Variation - Proposed Elevation G
(Inner/Outer Courtyard)
Scale 1:100

REV	DETAILS	INIT.	DATE
B	Amend following planning meeting	CG	07.09.2023
A	Material confirmation from client.	SCB	15.12.2022
TITLE Conversion of Existing Barns to Residential, Northdale Park, Raunds, Northamptonshire. DETAIL Elevation View G; Existing, Approved, Variation - Proposed.			
SCALE	1:100	SHEET	A1
DRAWN	SCB	CHECKED	22-036-156B
DATE	December 2022	ISSUE	PRELIMINARY

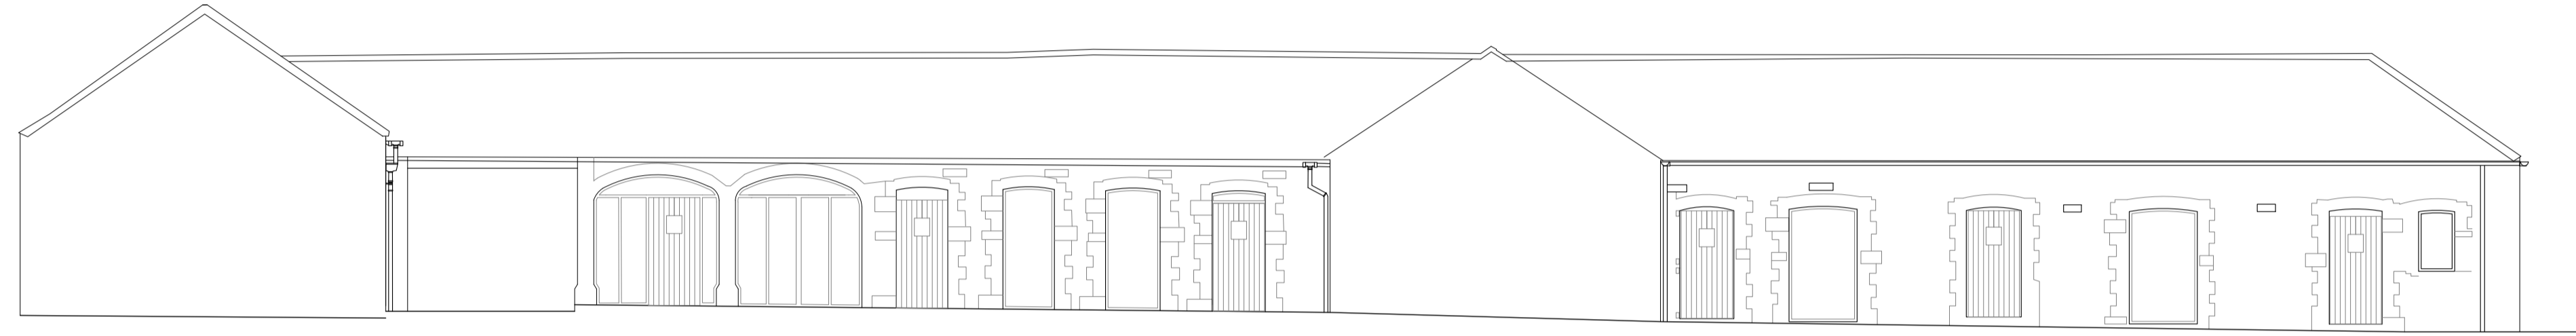
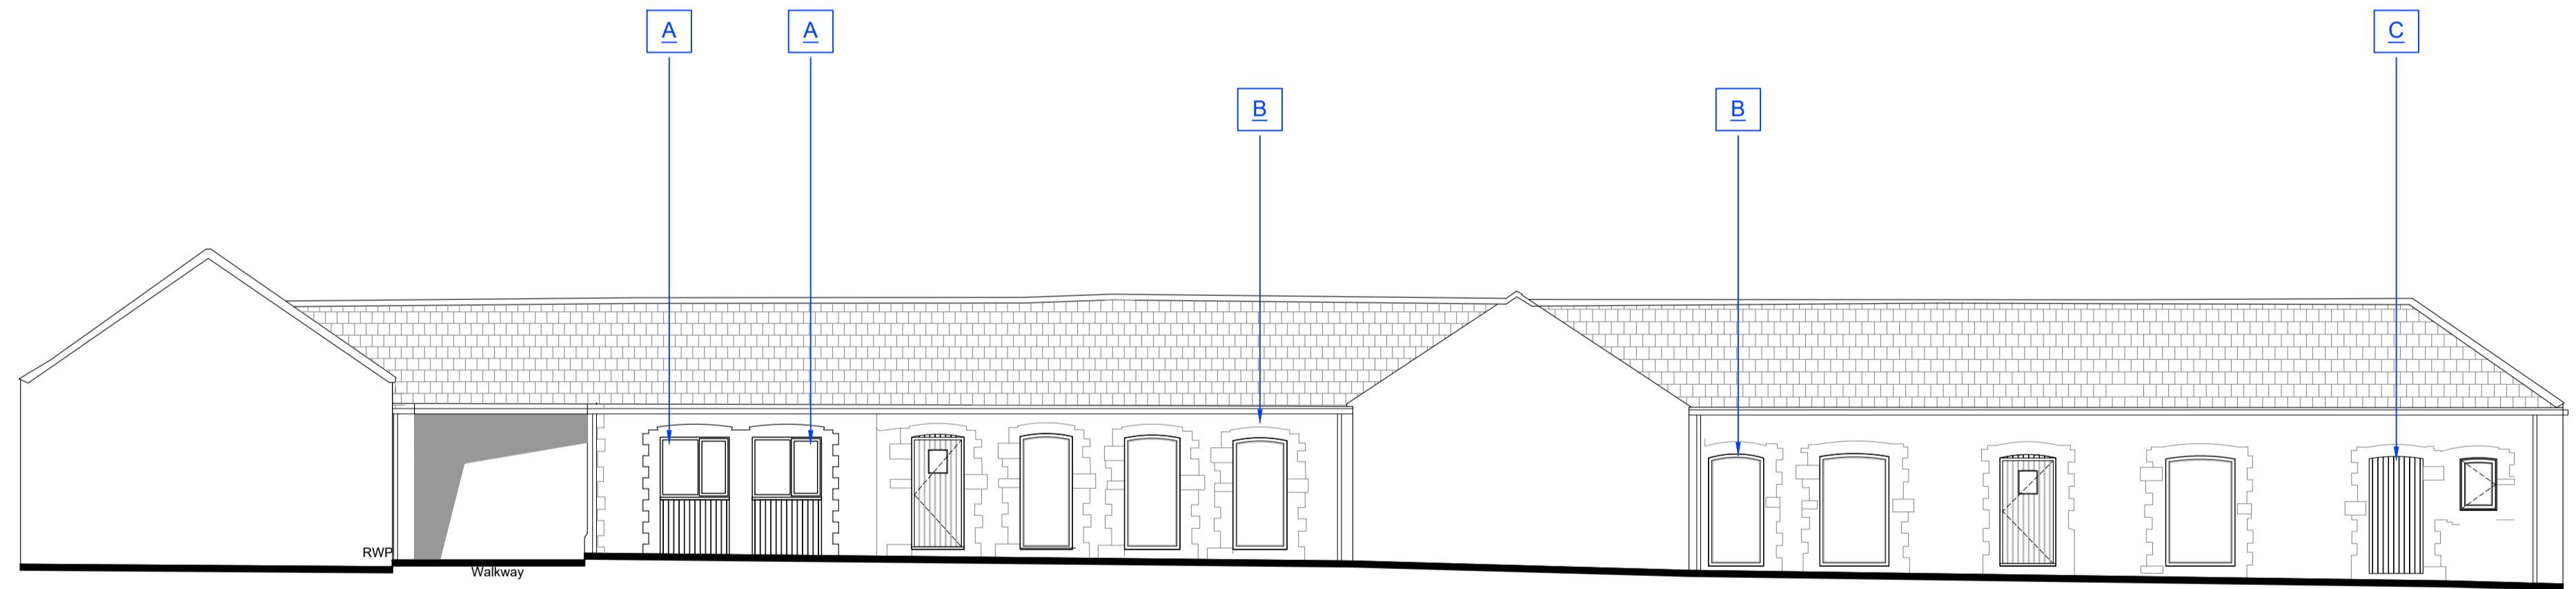
A Variation - Formerly approved door to be removed and glazing adjusted as indicated. Infill remainder of opening with stonework, brickwork and cladding.
Justification - Reduce excessive amount of doors within the approval and improve safety of Unit 4. Sympathetic use of proposed materials.

B Variation - Remove door and install fixed full height glazed panel.
Justification - Reduce excessive amount of doors within the approval and improve safety of Units 1 & 4.

C Variation - Existing opening to be infilled and finished with cladding externally.
Justification - Vast glazing already proposed to this room within Unit 1.
